NEW
RIVER

Burgess Hill

Design & Access Addendum

Proposed Section 73 Amendments

Consented Scheme - Proposed Elevations Block A1

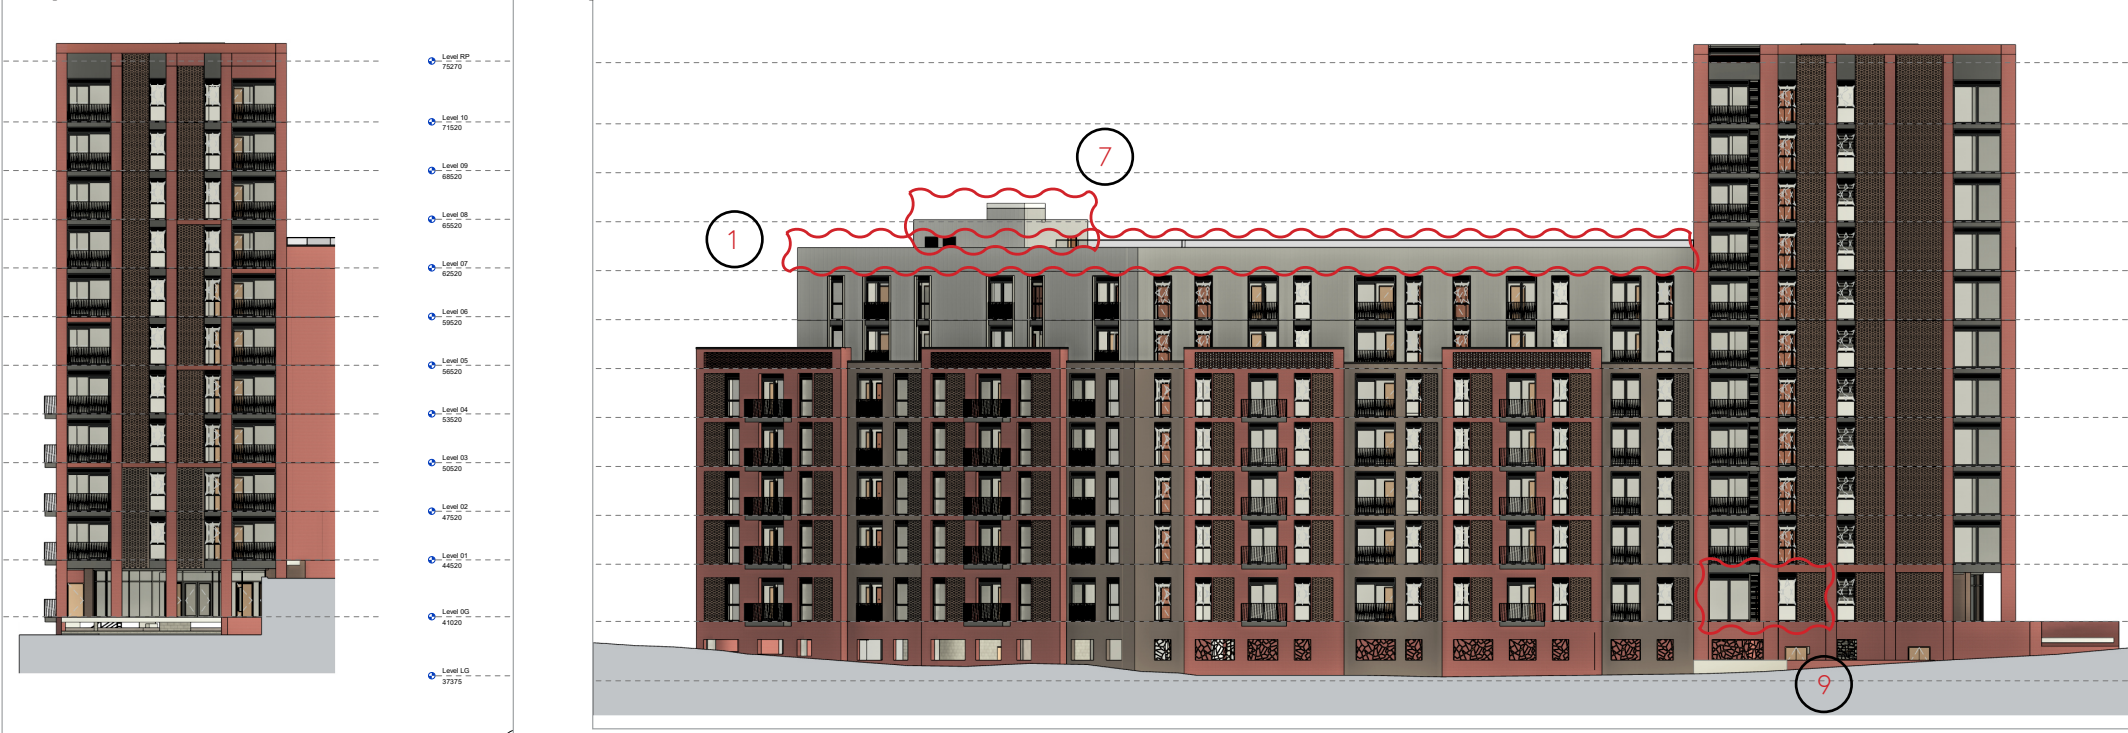
1. Parapet to the 7th floor roof increased in height from 150mm to 1100mm to screen SVPs, overruns, and limit the need for additional edge protection systems.

2. All apartment windows and external sliding doors increased in height to 2700mm, to accommodate supply and extract ventilation within ceiling voids.
3. External railings and balustrades simplified, and all glass balustrades changed to metal (to consolidate design language, reduce frequency of maintenance and reduce the effects of weathering).

4. Brick detailing added to 'tower' North elevation to visual soften solid brickwork mass.
5. Window sizes reduced or moved, to ensure glazed areas are at least 2m away from the boundary on the East and South 'tower' elevations.

6. Hoist for Plant Equipment to roof of southern block included.
7. Northern stair core connected to roof level 07 to allow for second means of escape from communal garden.

8. Internal courtyard elevations changed from white render to red brick (to reduce the effects of weathering, reduce the frequency of maintenance, and to tie in with adjacent elevations).

9. Adjustment to Southwestern elevation window arrangement at Level 01 due to stair core position abutting facade as detailed on the above page.

Proposed First Floor Plan - Block A1

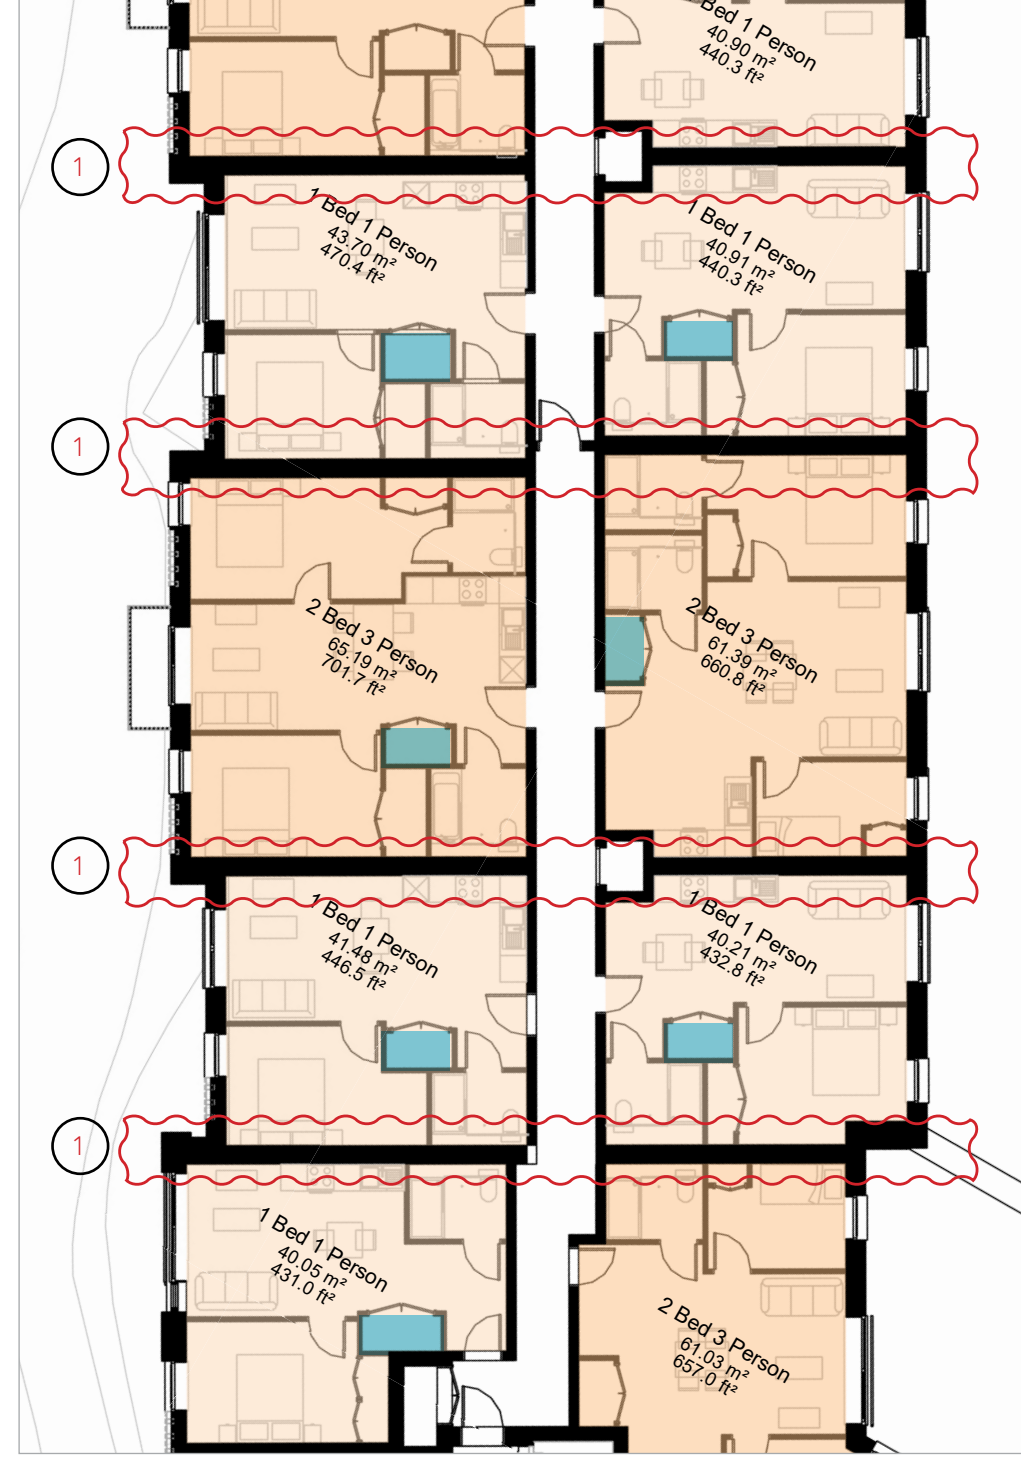
- 1. Internal and external walls increased in thickness to accommodate structure and satisfy thermal requirements.
- 2. Bedroom and living room sizes standardised to better satisfy national housing space standards
- 3. Utility space in all flats standardised to 1500mmx800mm.

Proposed Basement Floor Plan - Block A1

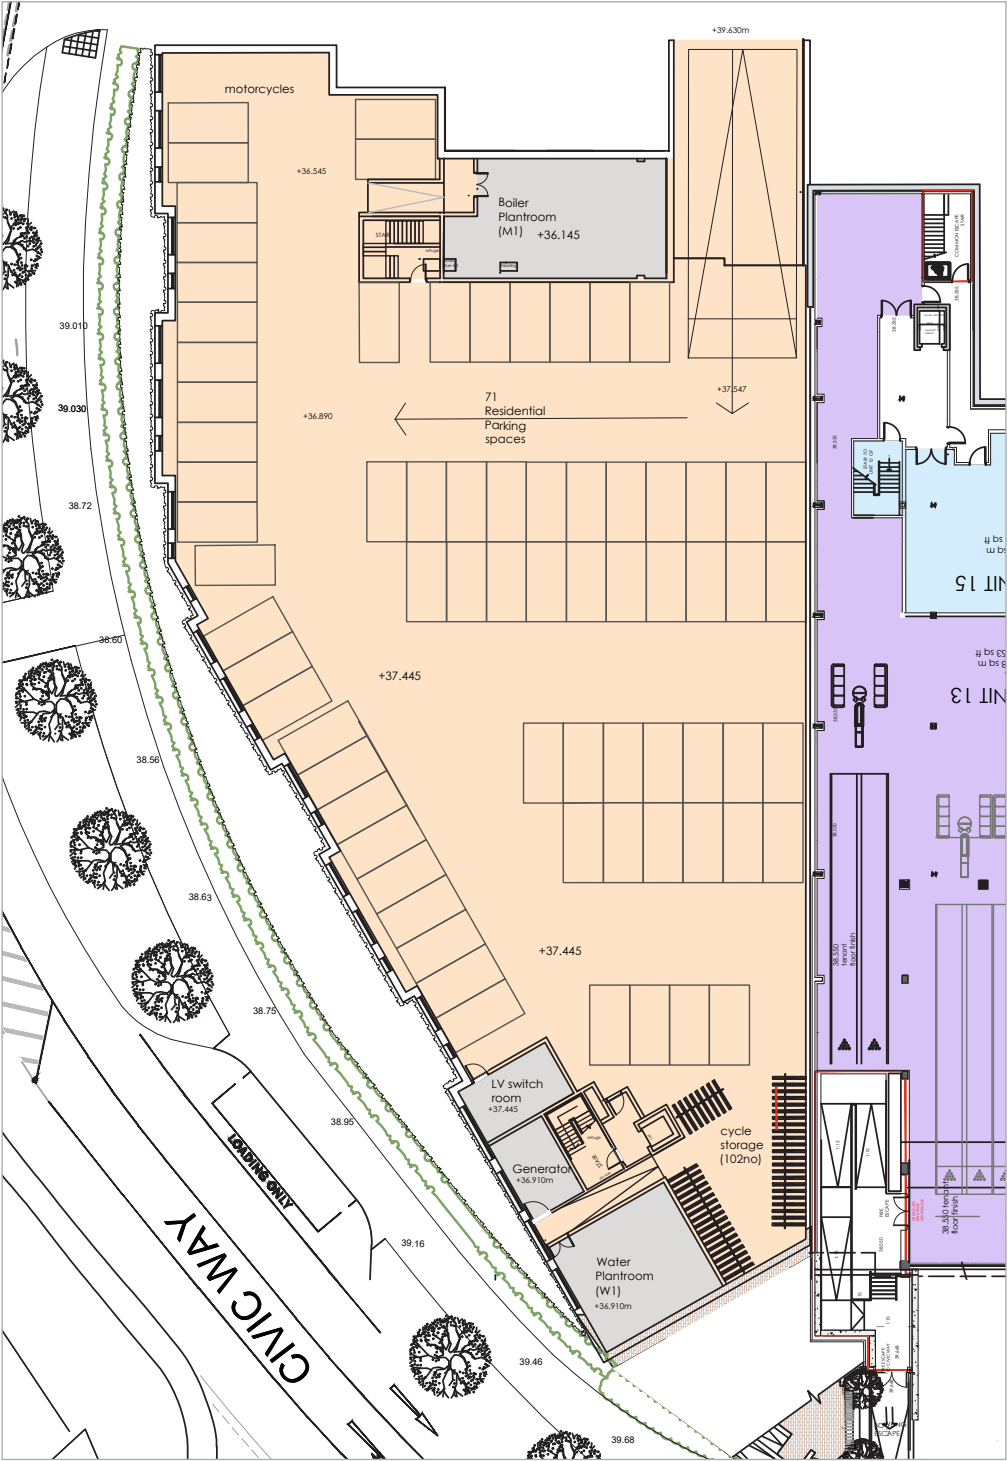
- 1. Bin store split into two stores to ensure all flats are within 30m horizontal travel distance of a waste/recycling disposal point
- 2. Cinema/Gym Space Adjustment to accommodate second stair in tower element of the scheme.

Proposed Lower Ground Floor Plan - Block A1

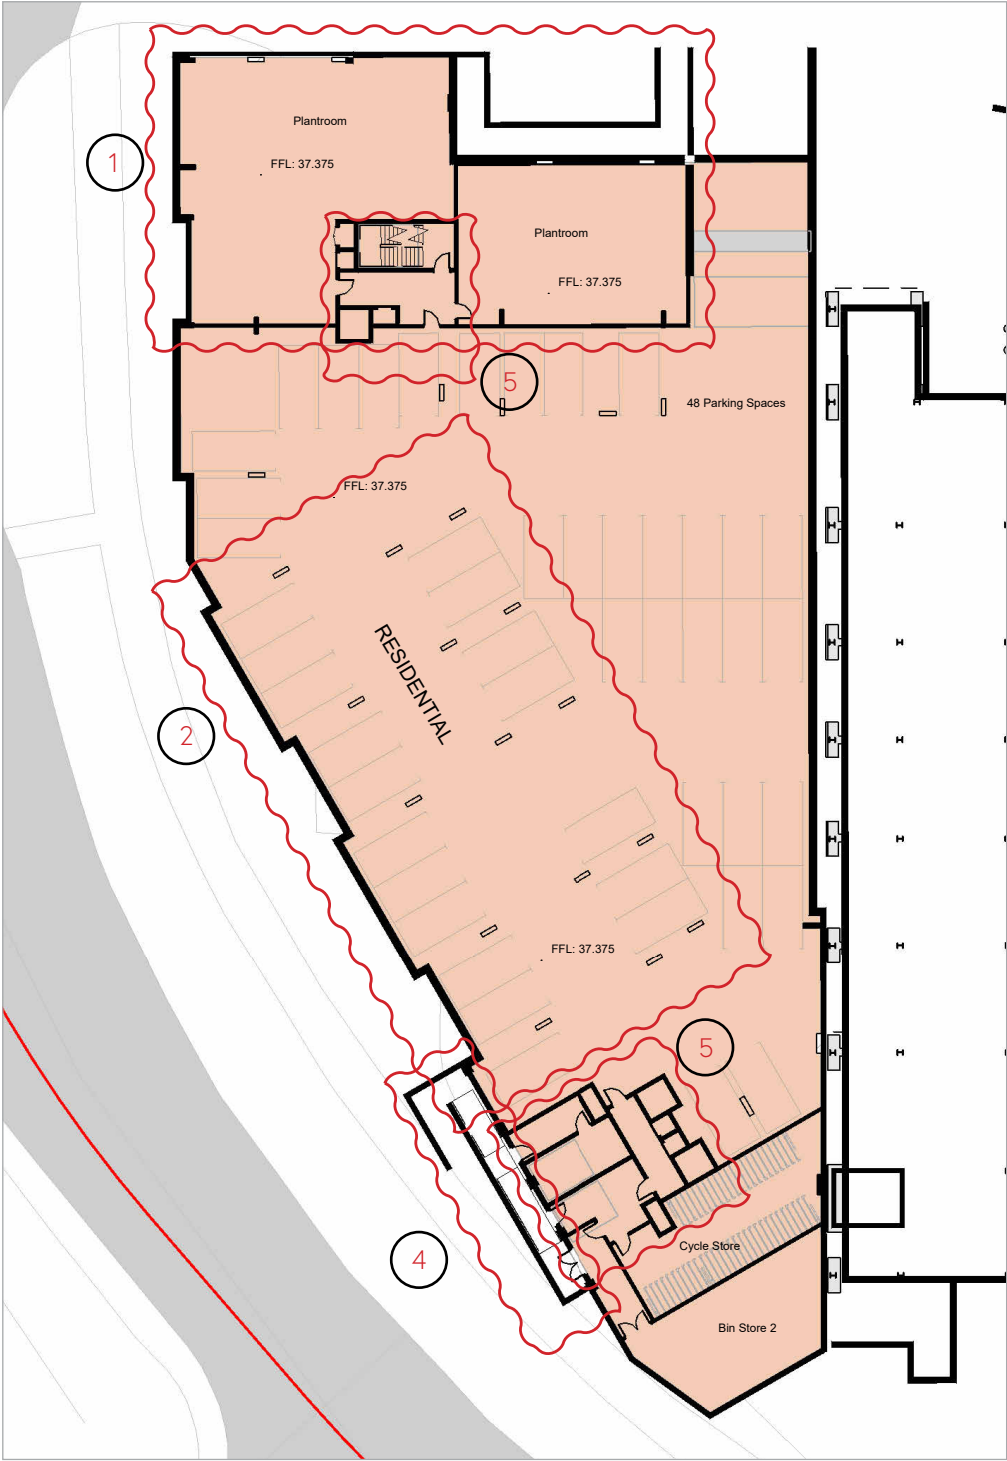
- 1. Increased Plant Zones allocated to allow for increased sprinkler tank requirements including a commercial grade sprinkler system for the basement car parking given the requirement for passive EV charging to all parking spaces.
- 2. LG car park layout revised to accommodate structure.
- 3. In the consented application there were 71 spaces in the lower ground floor level of the residential block, in the revised proposal this has reduced to 48 spaces. 23 residential parking spaces have been relocated from the lower ground level of the residential block to the external car park adjacent to Civic Way to ensure total number of spaces remains unaltered.
- 4. Pedestrian and cycle ramp, for entrance and egress to LG, added to Civic Way West elevation.
- 5. Lobbies to bin stores and stair cores amended, added, and increased in size to meet fire strategy requirements.

3.2 Bowling Alley Relocation

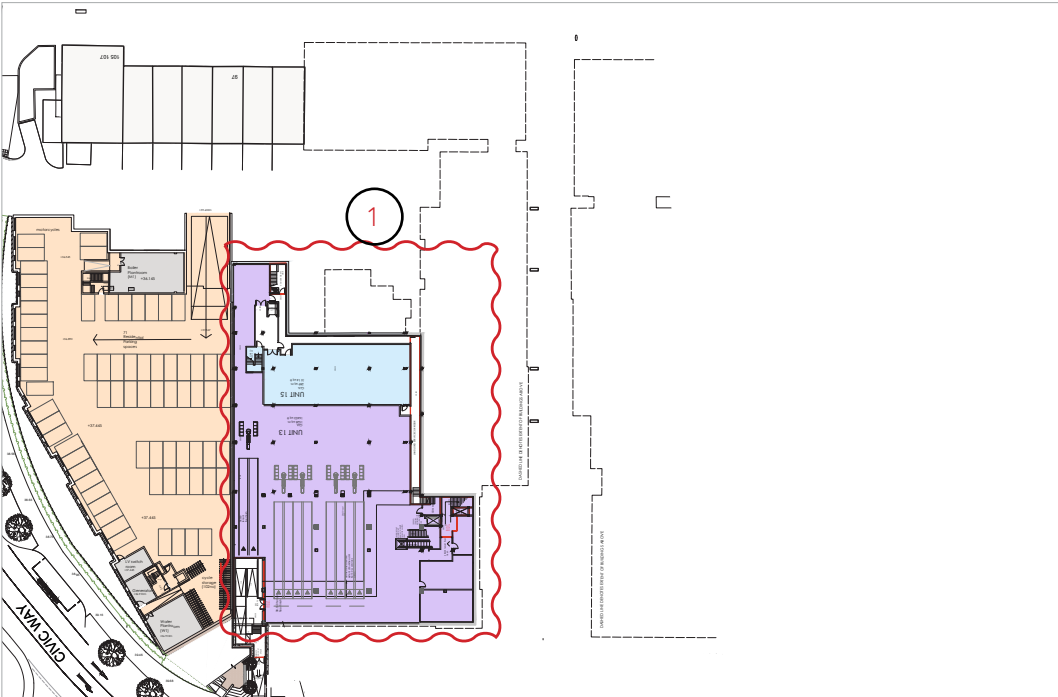
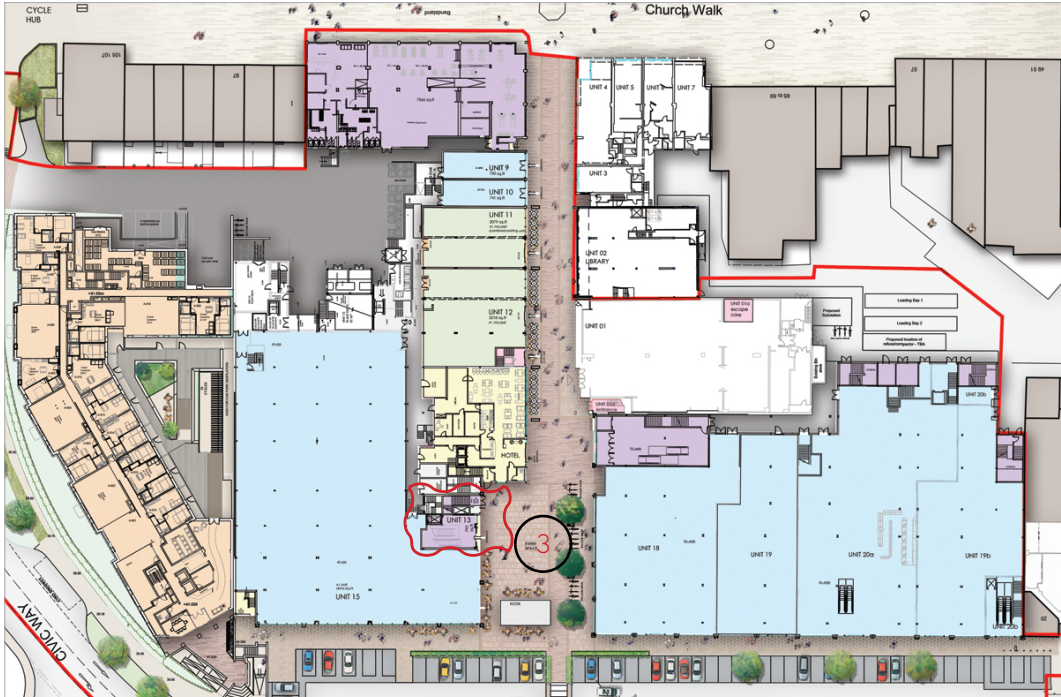
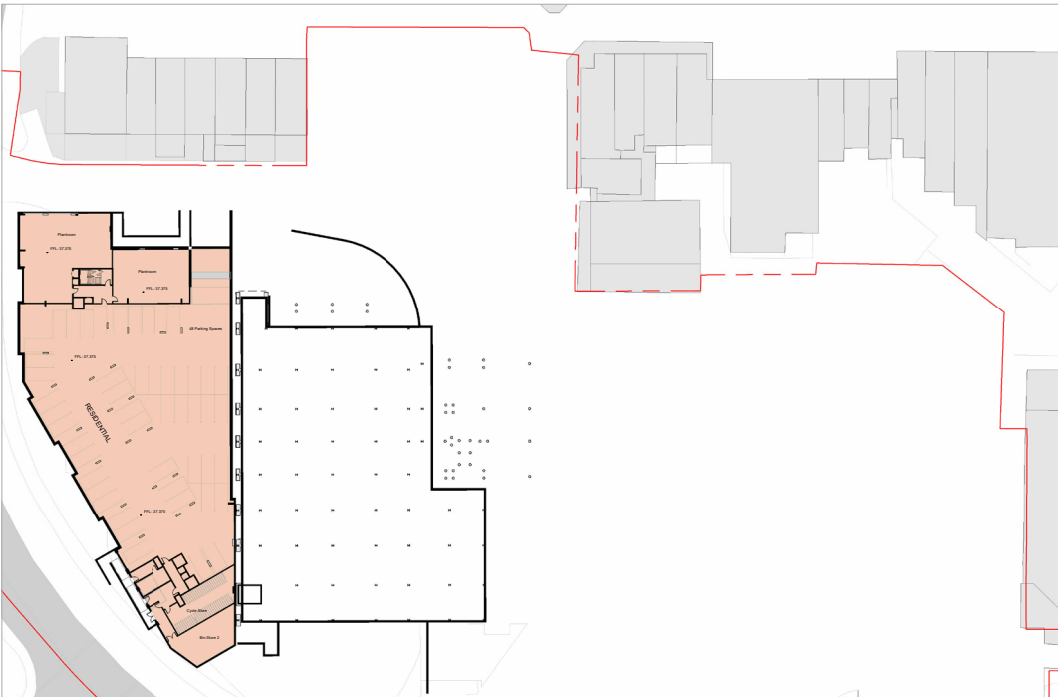
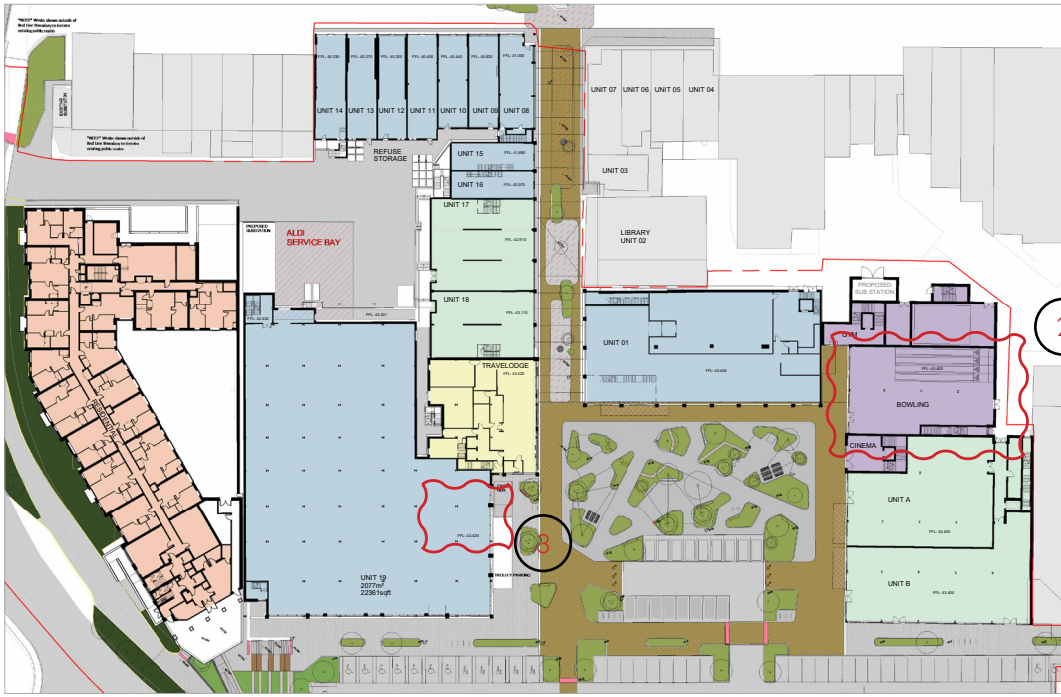
- 1. The proposed conversion of the Basement (Level 00) below the proposed Food store has now been omitted from proposed Block A2.
- 2. The basement was previously allocated for Leisure Use as a Bowling Alley, numbered as Unit 13. The proposed Bowling Alley (previously Use Class D2 now Use Class E) has been relocated within the Leisure Block - refer to Block B. The basement space, which is a result of the site's topography, will be left voided and will be enclosed.
- 3. The ground floor entrance to the Bowling Alley, from the external event space, and the associated second fire exit into the service yard are no longer required, and the footprint of those areas is absorbed into the proposed Food store (previously Unit 15).
